**LEGAL ADVERTISEMENT
HISTORIC PRESERVATION BOARD
CITY OF PORTLAND
Public comments are taken at all meetings.**

HISTORIC PRESERVATION BOARD AGENDA

May 18, 2016, 5:00 p.m.

VIEW 2 - Mellen St

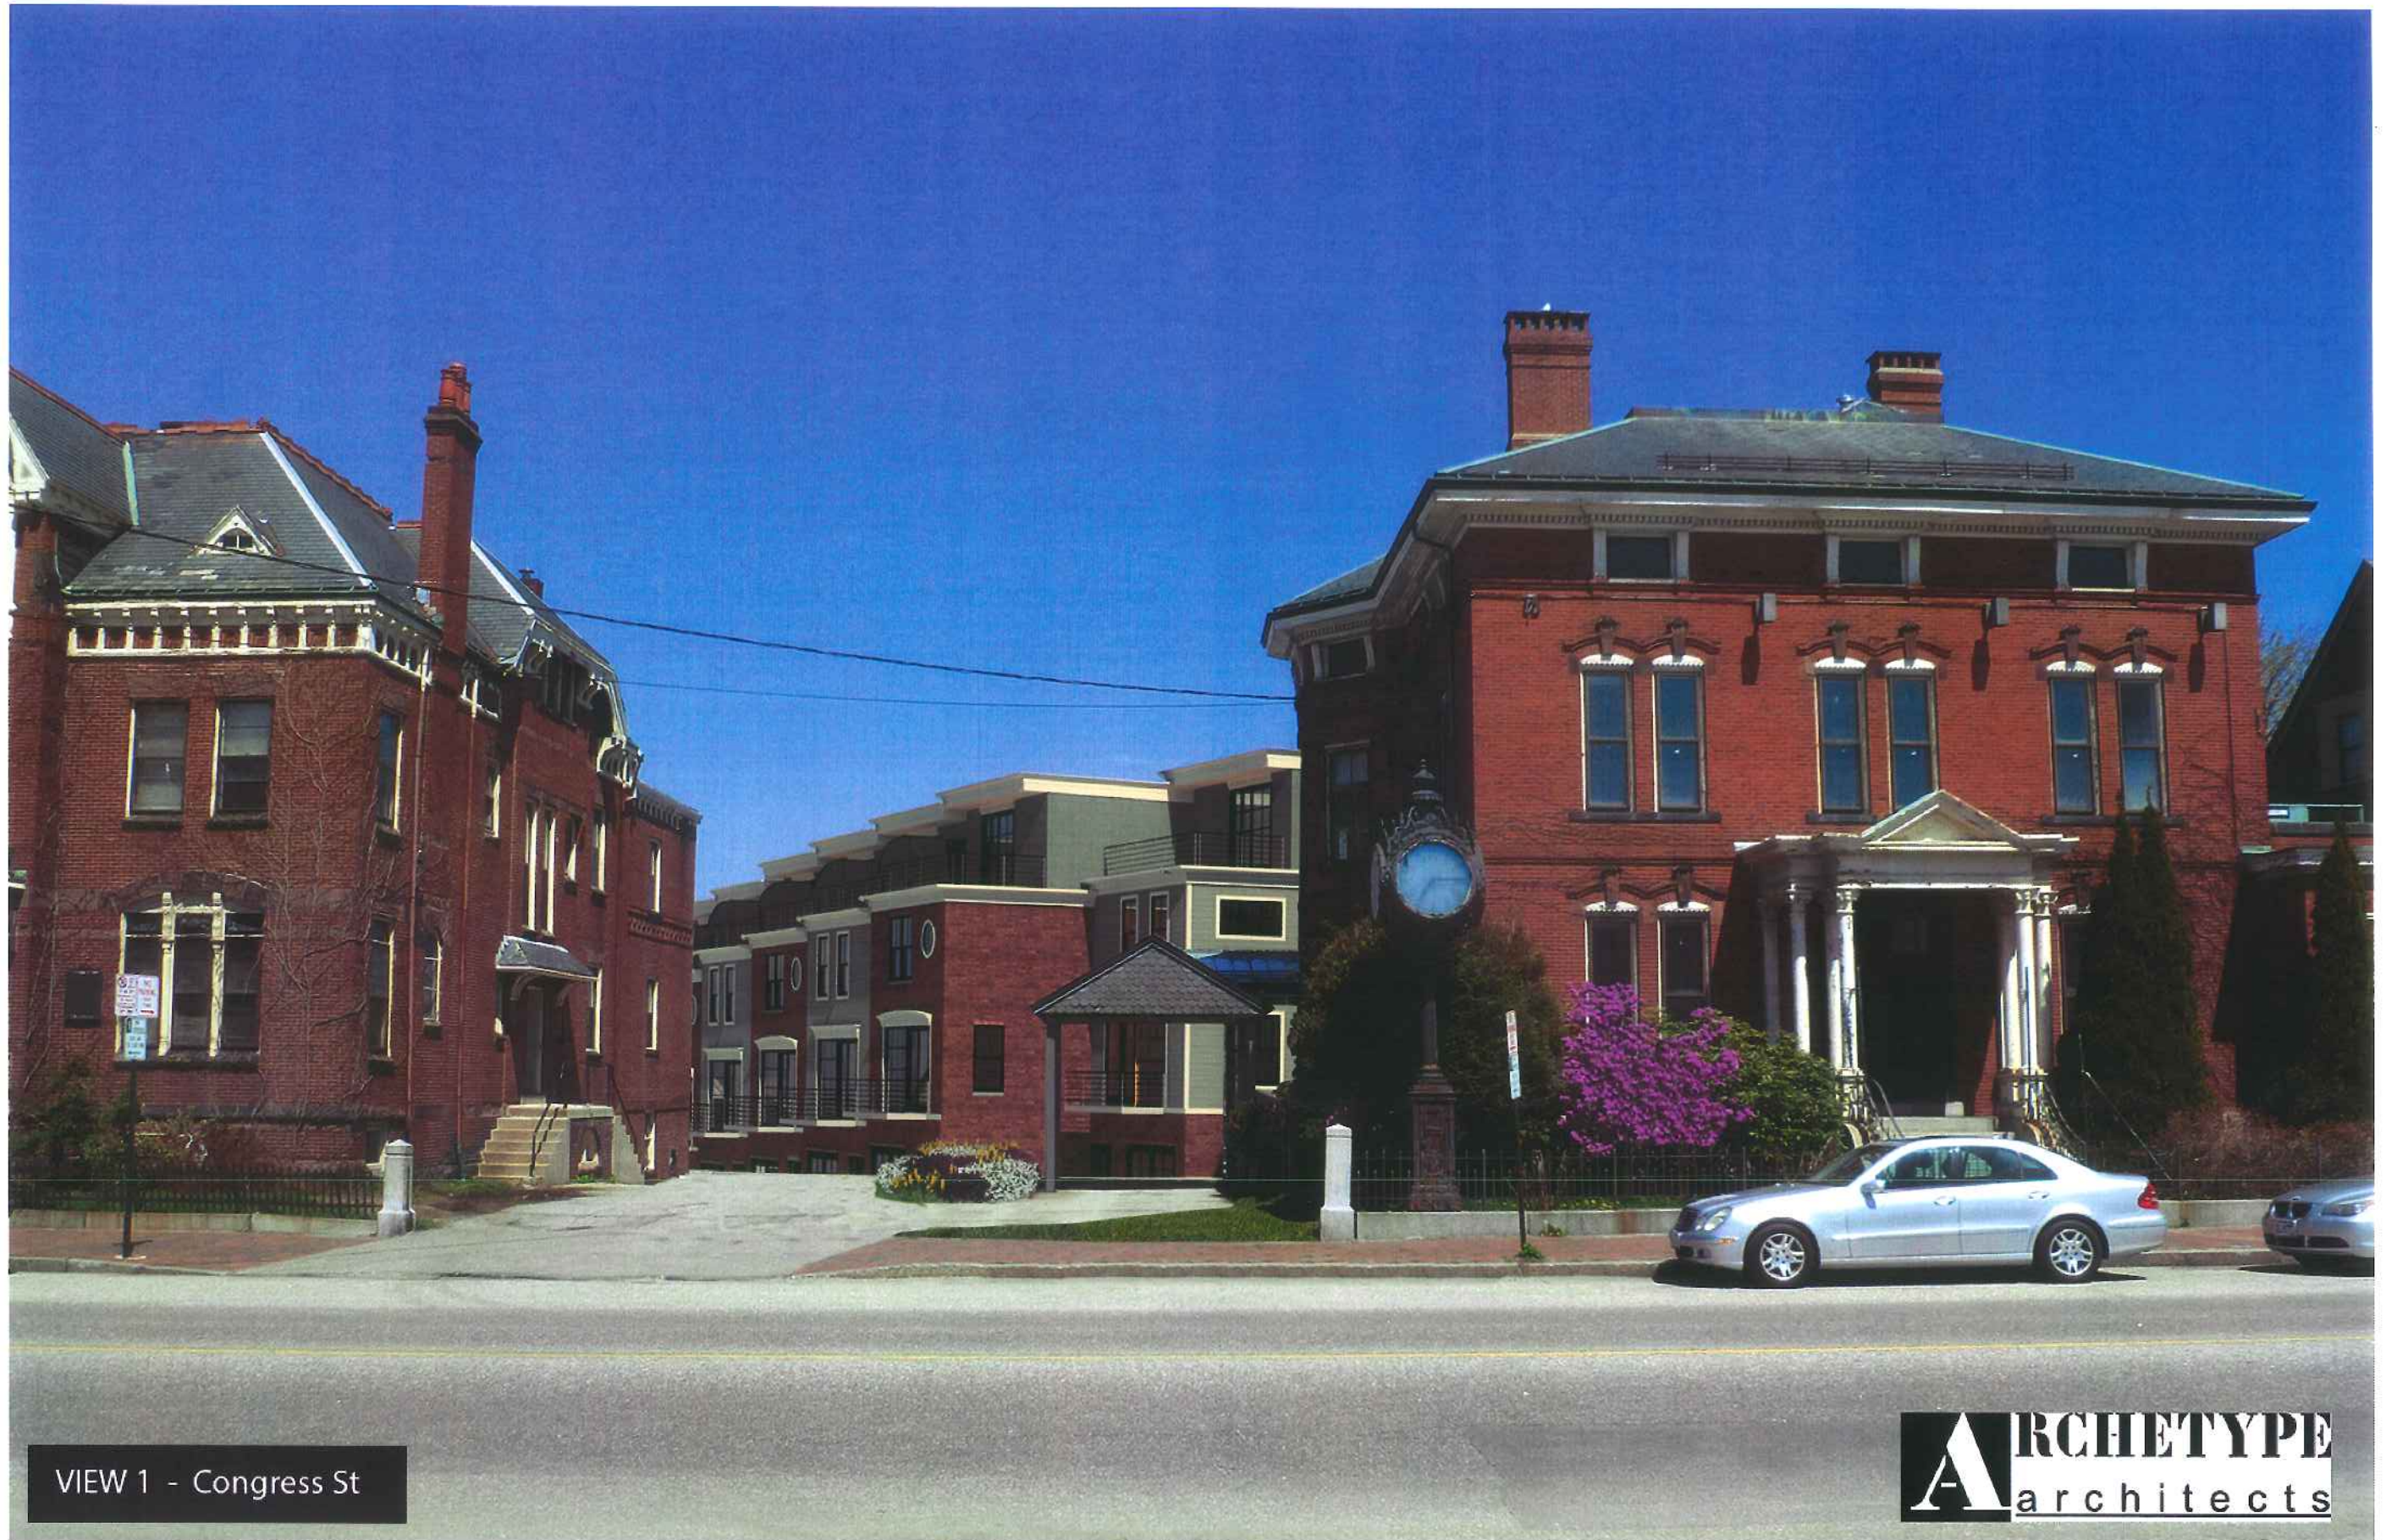
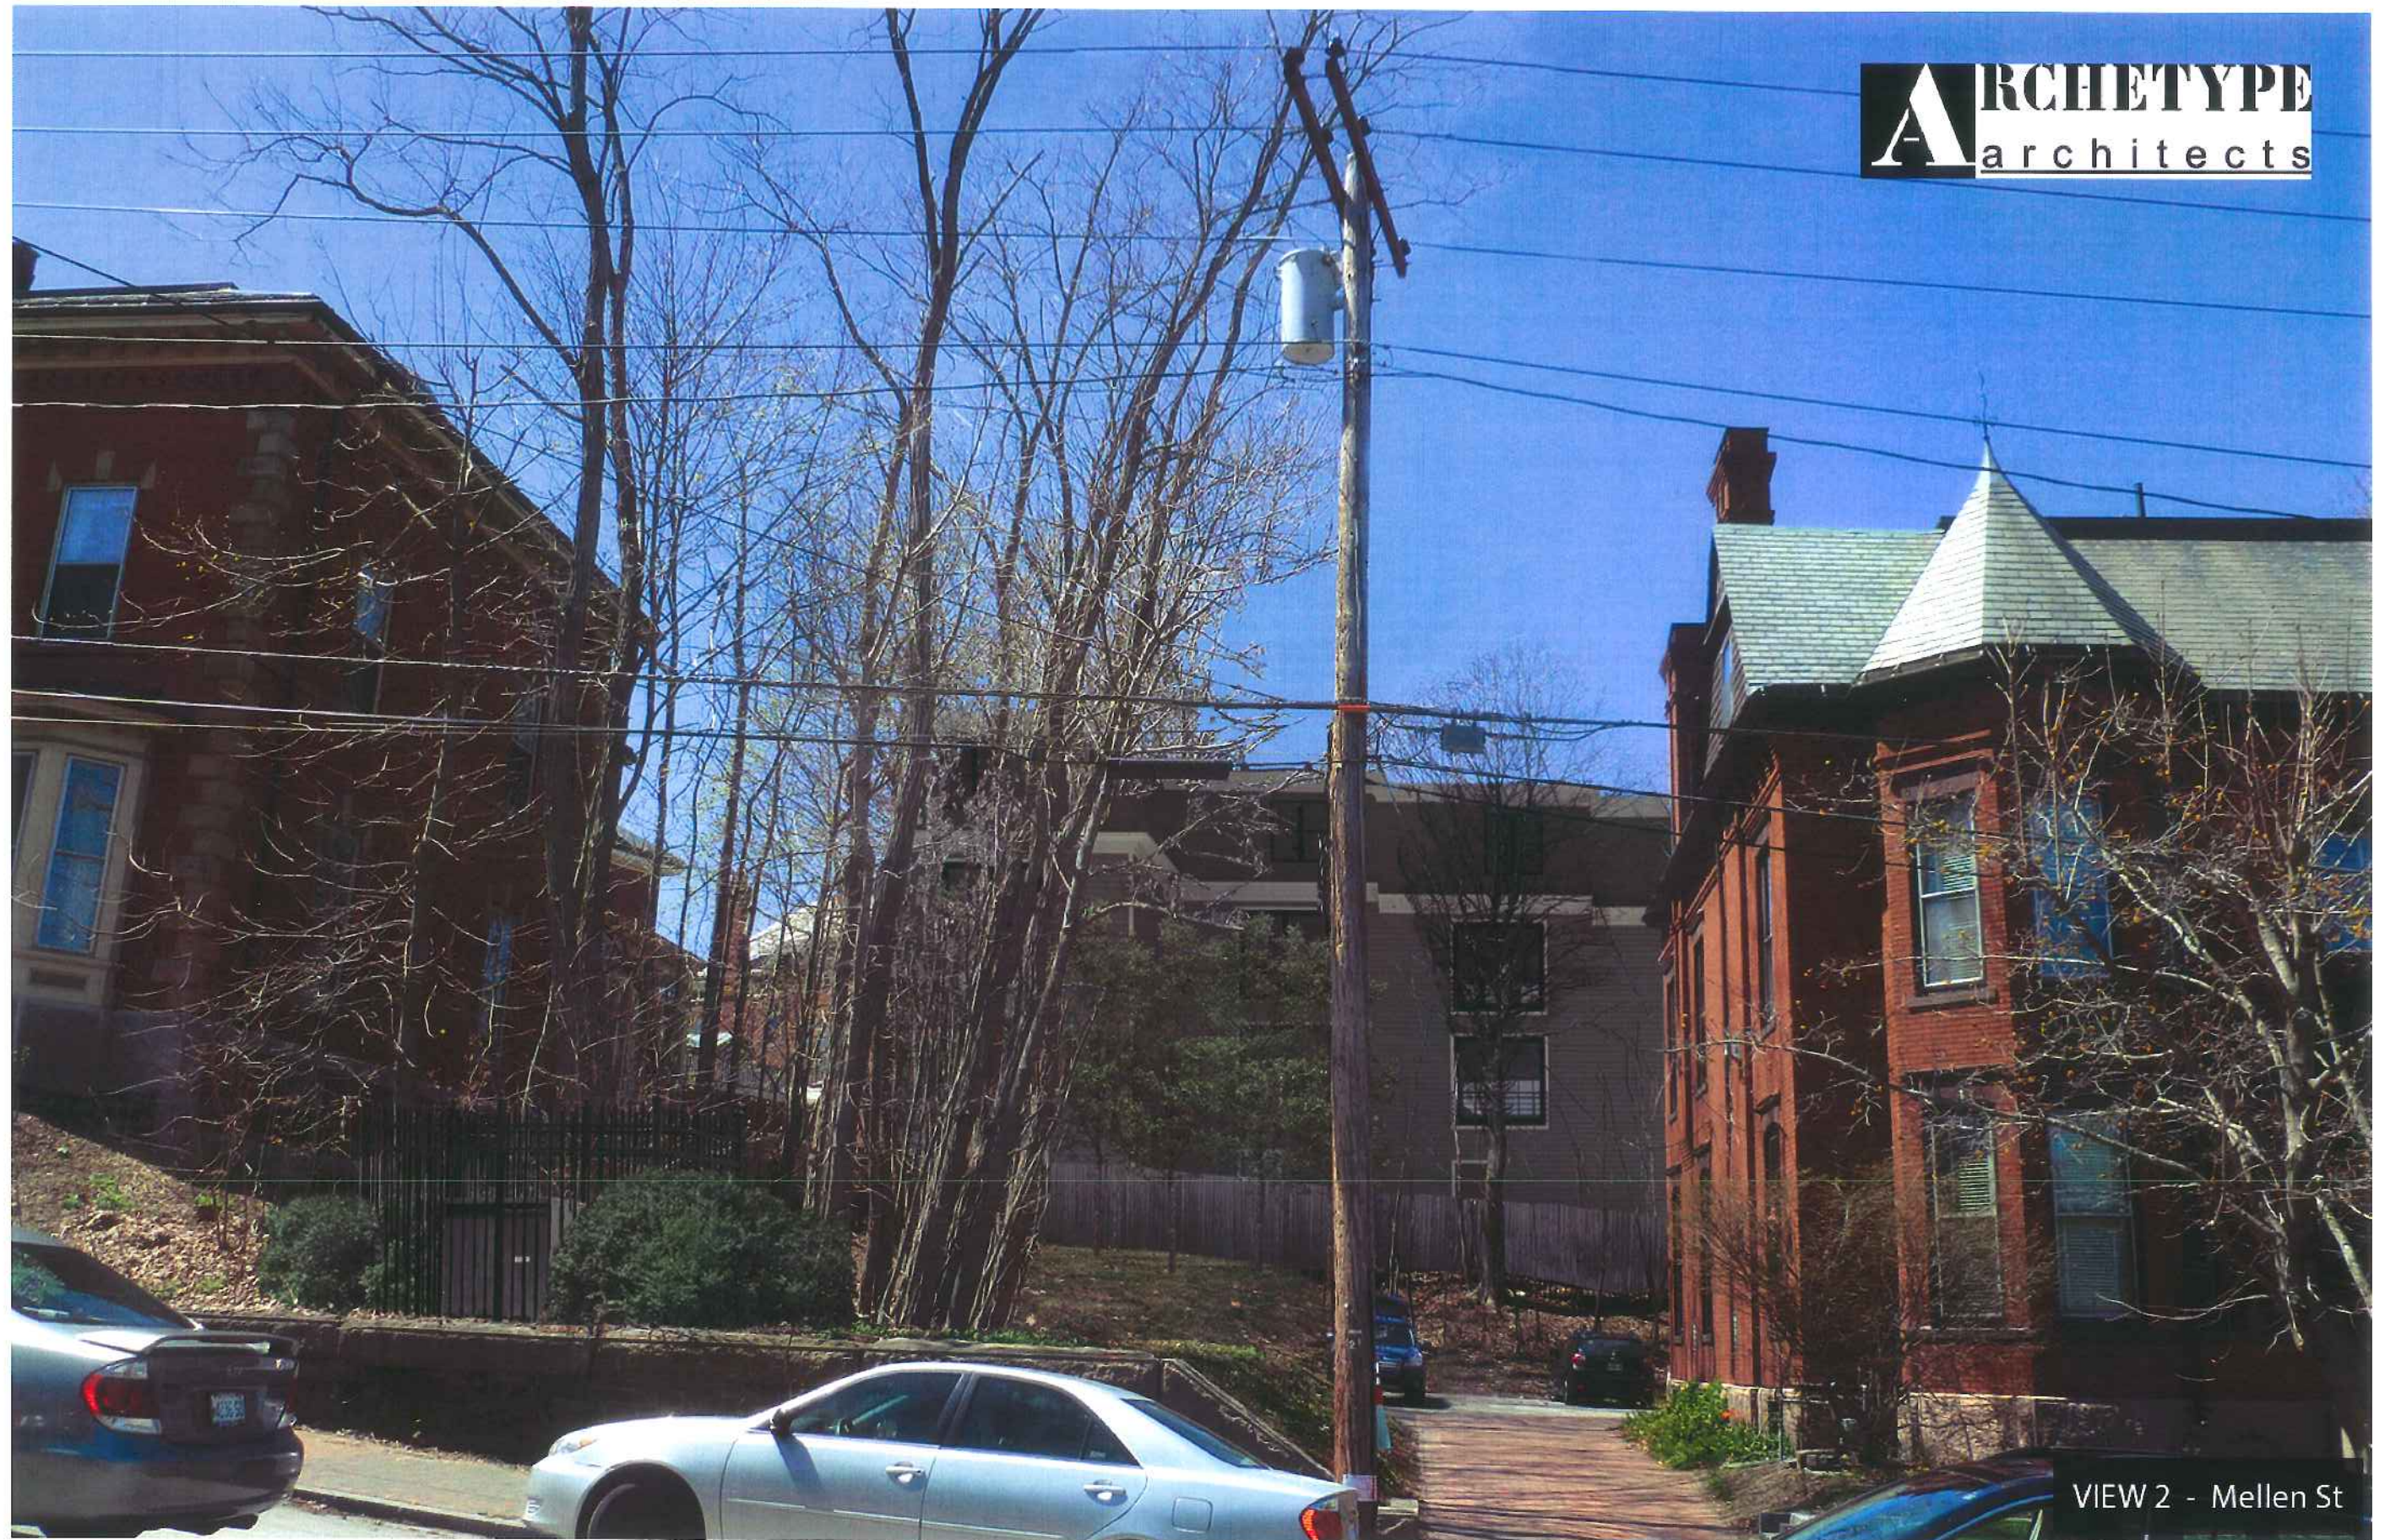
The proposed site plan and View 2 of the computer-generated photographs show a concrete pad with electrical transformer located immediately behind an existing stone retaining wall along Mellen Street. (This is on the narrow portion of the applicant's property that extends to Mellen.) The computer-generated image shows the transformer surrounded by a metal fence. The sewer line and gas line are proposed to run through this area as well. The land is currently wooded and provides a vegetated buffer between adjacent Mellen Street houses.

- Staff questions the proposal to locate the electrical transformer for the project immediately behind the Mellen Street sidewalk. At the edge of the sidewalk is a mortared stone retaining wall with granite cap. Behind the wall is a wooded area that provides a landscaped buffer between the two abutting residential structures. The introduction of a large transformer with concrete pad just behind the stone wall would represent an incongruous element within this historic streetscape. The introduction of metal fencing surrounding—see photo-- would also seem arbitrarily placed.
